POOL 2023-160640

PERMIT # OSWP-2022-7001

SEPTIC: IMPROVEMENT PERMIT / AUTHORIZATION TO CONSTRUCT / OPERATION PERMIT / EXISTING SYSTEM

SITE ADDRESS: 170 HIDDEN MEADOWS DR, MOORESVILLE, NC 28117 | PHONE: 7043101832 | ALT. PHONE:

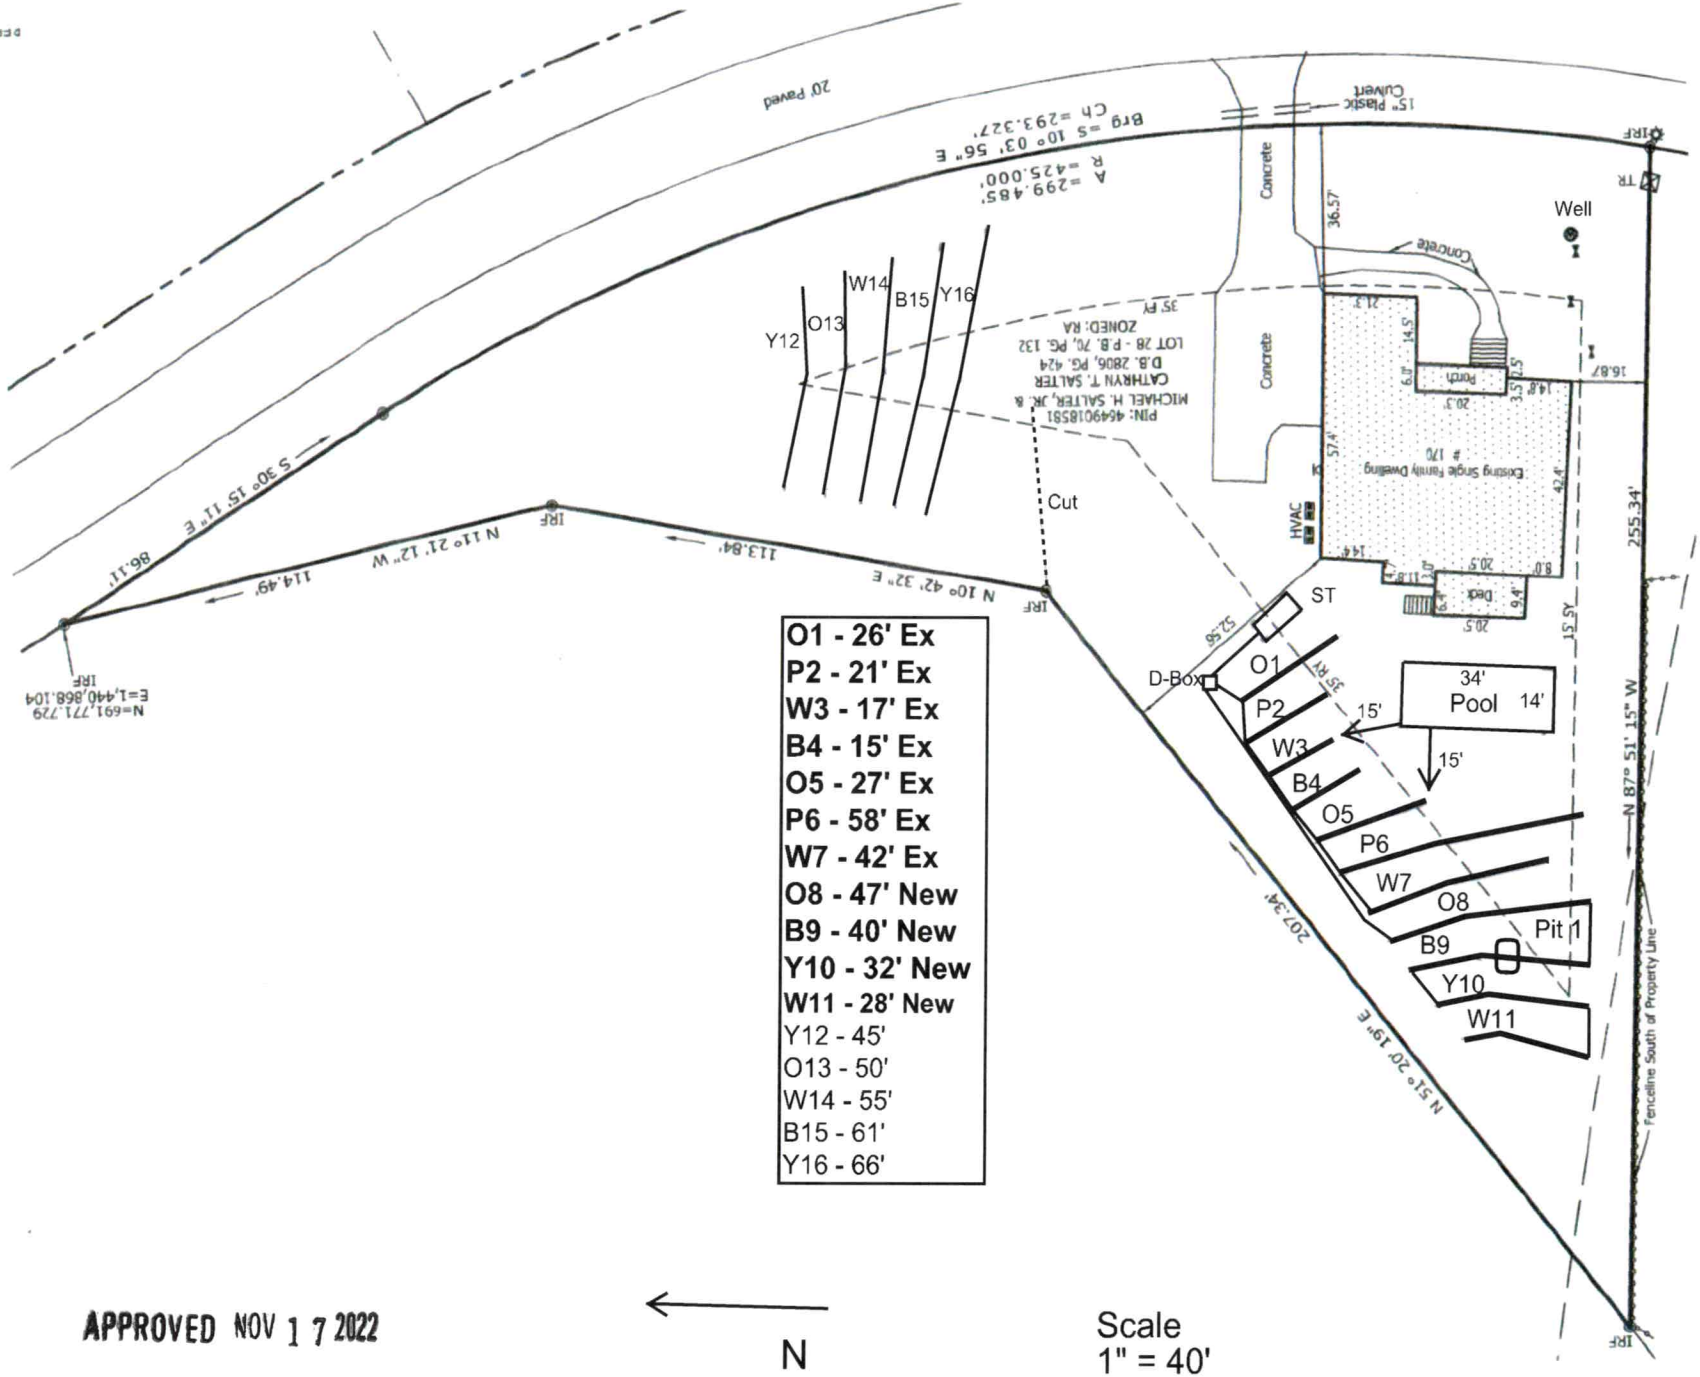
Comments:
The existing system must be modified for a pool. The O1-O5 must be shortened and new Horizontal PPBPS installed to make up what is lost. A distribution box will split the flow between the existing lines and the new lines. The horizontal PPBPS lines will be fed by serial distribution.
The repair remains in the same area.

Russ
To clarify for Iredell county, we are proposing to use a distribution box to gravity feed two horizontal panel lines that are 75' and 72'. Both of these lines are comprised of two lines that are serial fed. This is the proposed option you are approving, correct?

After looking over your proposed design, I honestly like the second option. Having two lines fed via another d-box would be our go to, especially considering how close in total line length they are. Please let us know if you have any questions.

Given these two options, our recommendation is that you use a distribution box to gravity feed two horizontal panel lines that are 75' and 72'. Both of these lines are comprised of two lines that are serial fed.
